PLAN REVIEW COMMENTS

DATE: 02.07.13

■ SHINNWOOD WEST [4th Review]

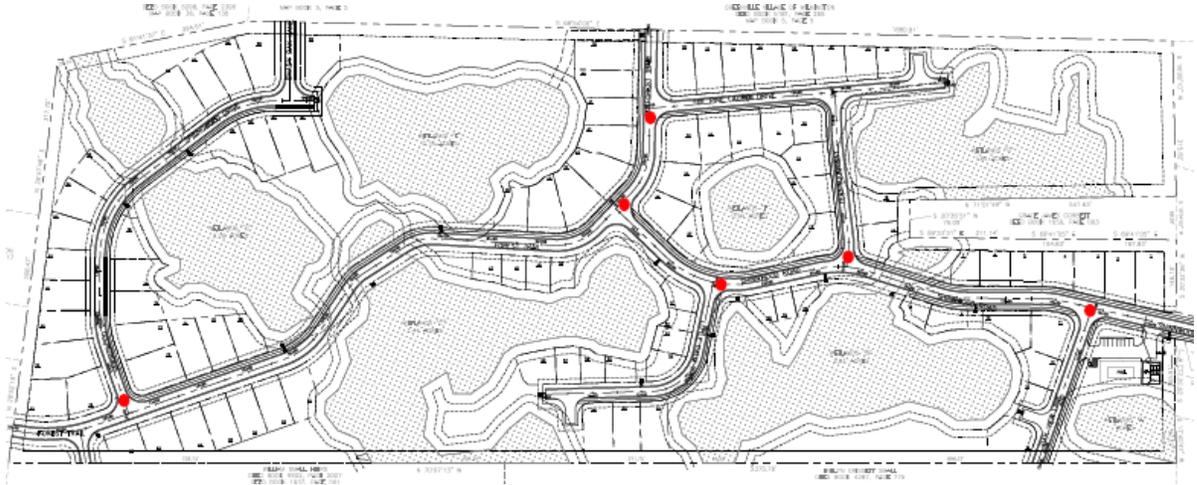
4. Install wheelchair ramp(s) at street corners per City standards. Connect sidewalk (s) with ramp(s). Please show the wheelchair ramps on the site plan(s).
4th Review: Show the wheelchair ramps on the plan at all locations. Provide receiving ramps in the following locations (red circle intersections):
